DRAINAGE REPORT

PROJECT: 22A267

PCD File No. PPR2325

**Town of Ramah Wastewater
System Improvements**

PROPOSED DRAINAGE PLAN

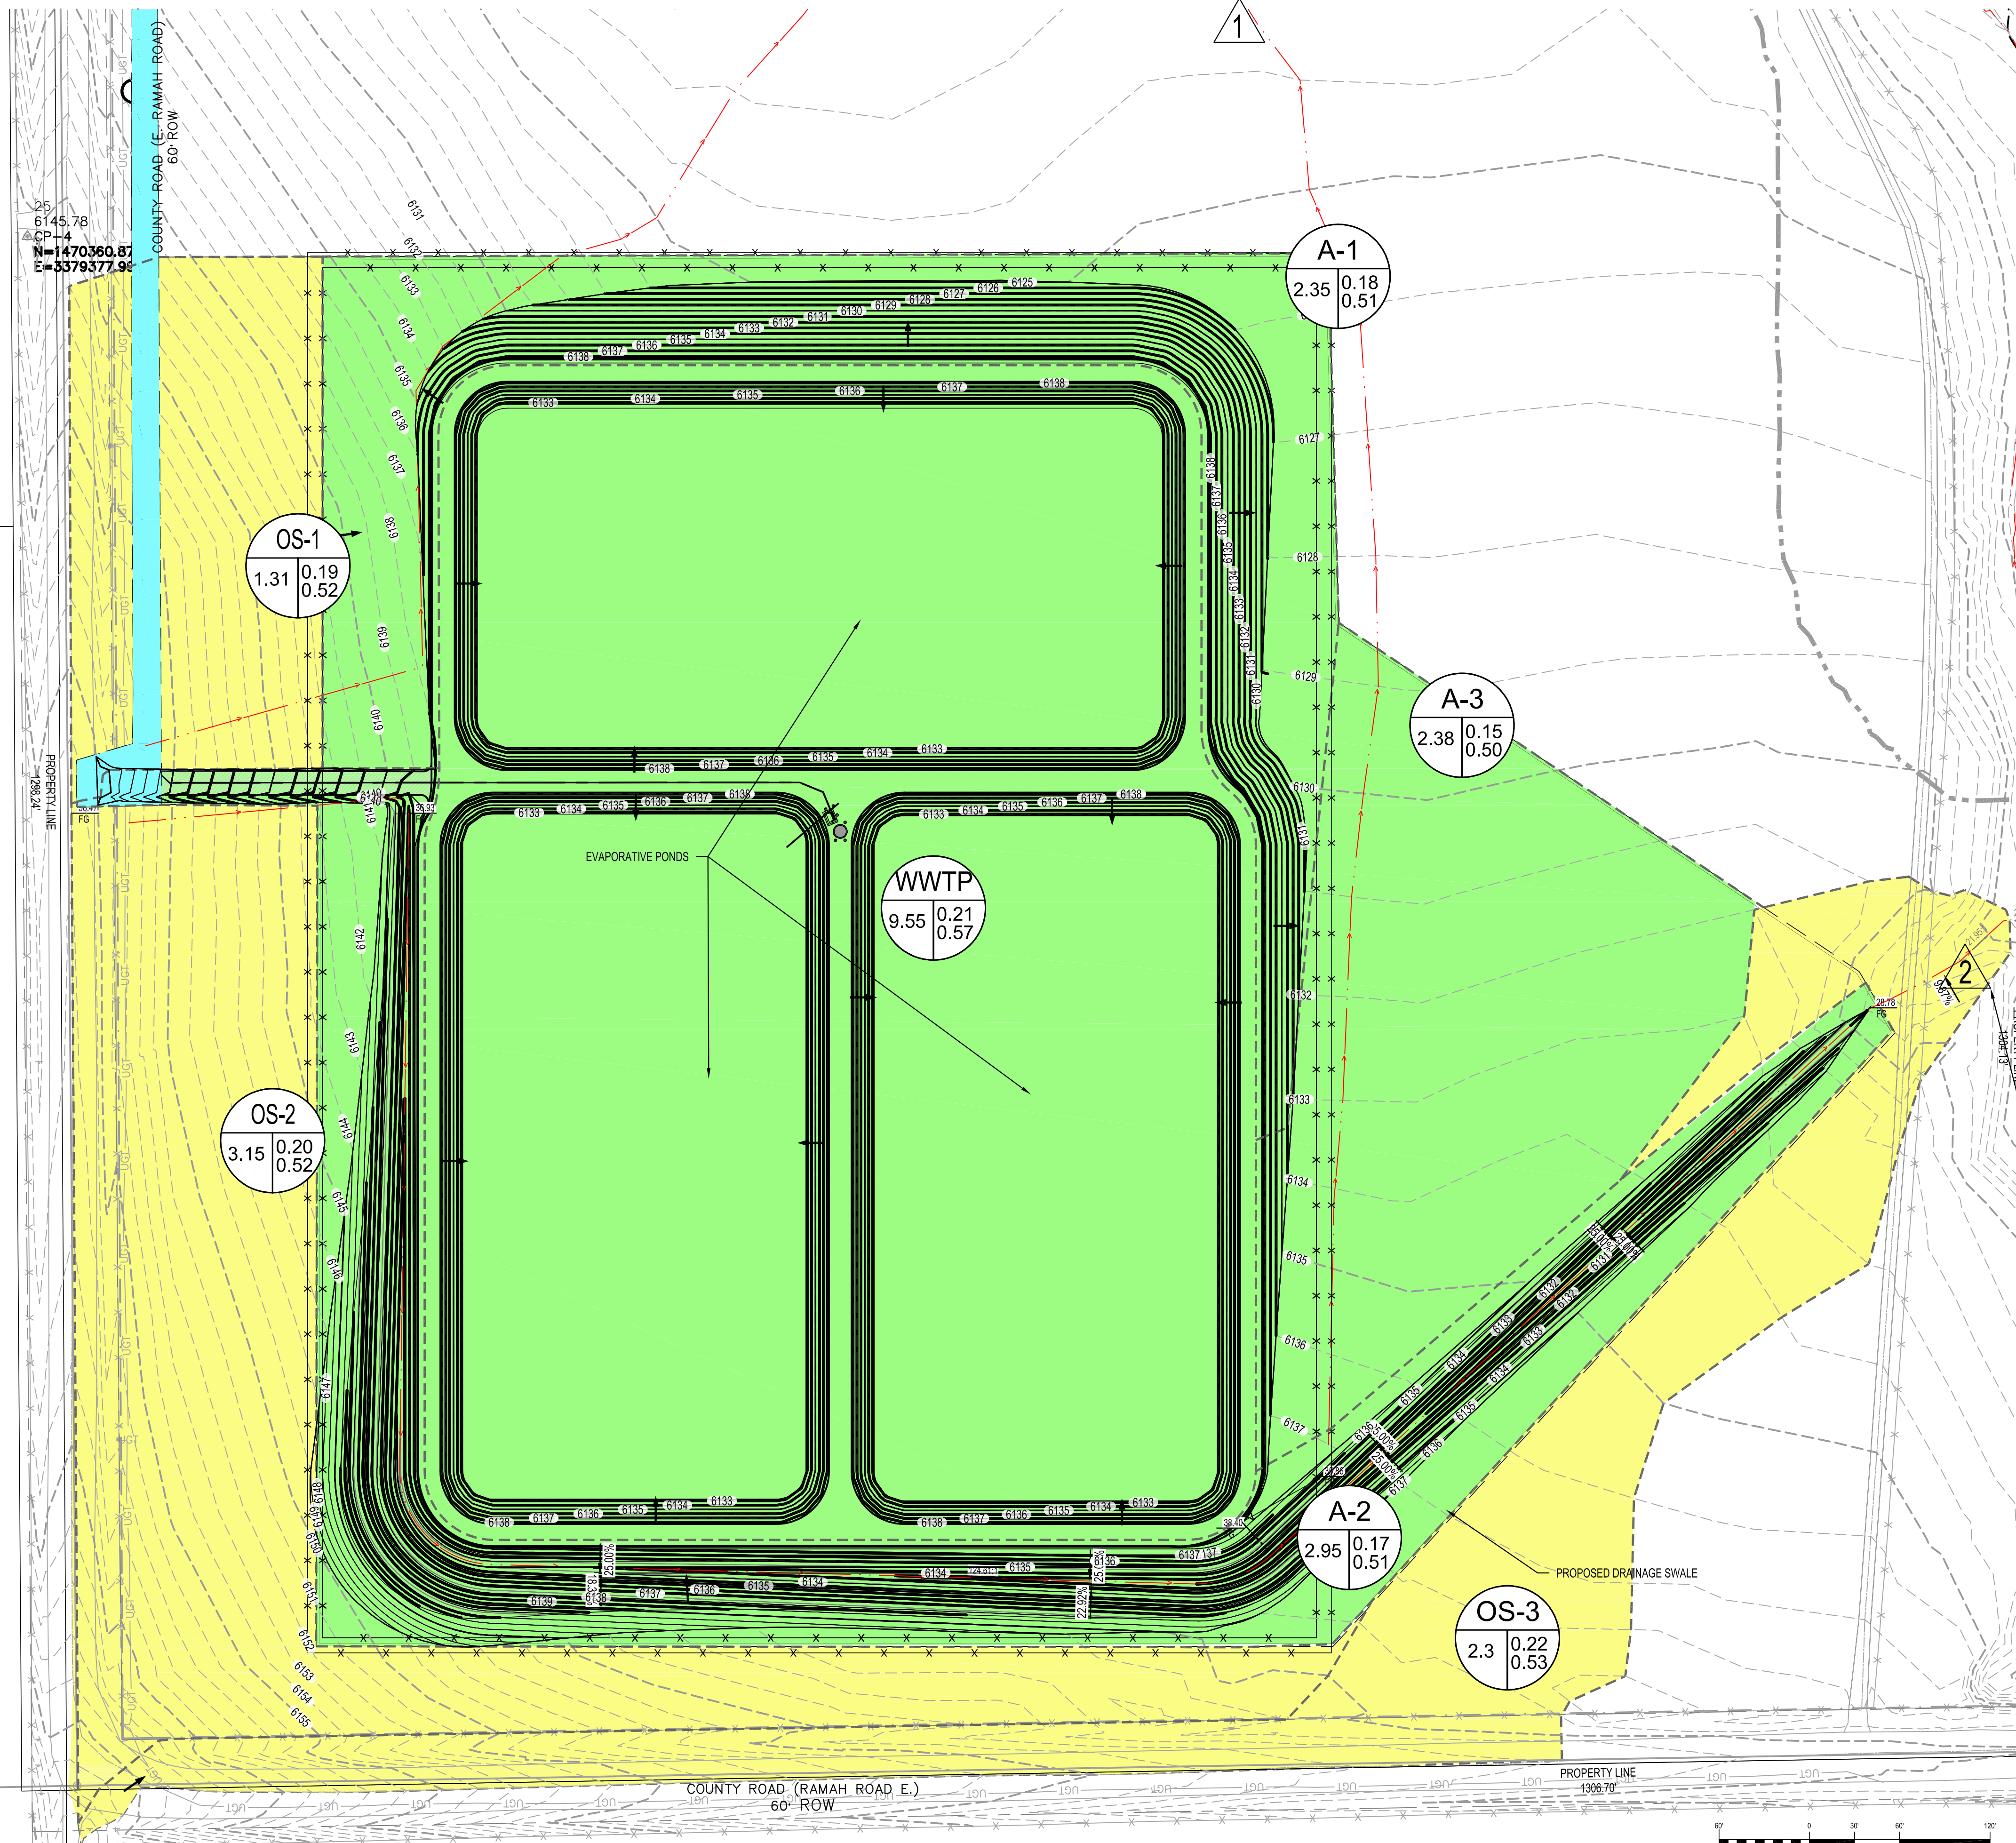
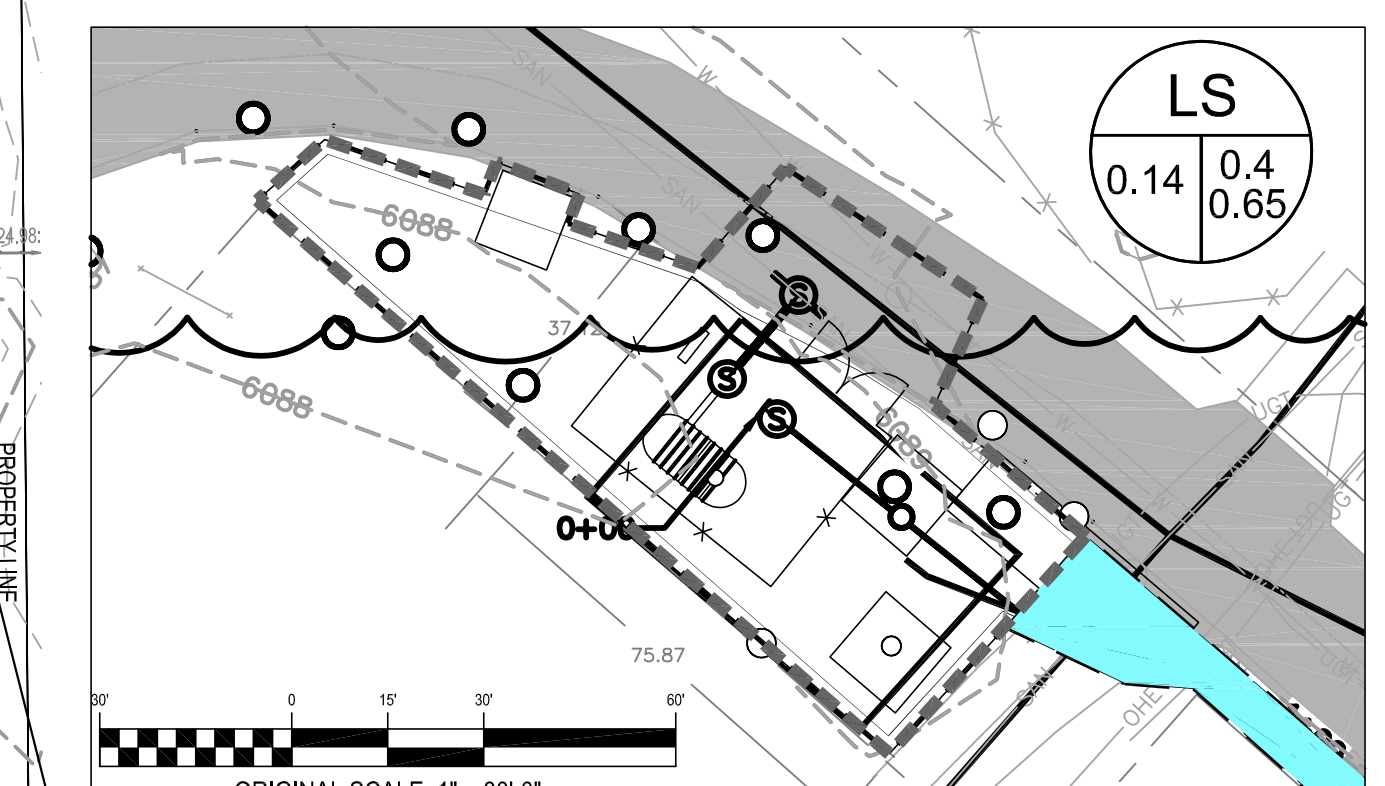
Verify these values

This area can potentially be excluded under ECM App I.7.1.C.1
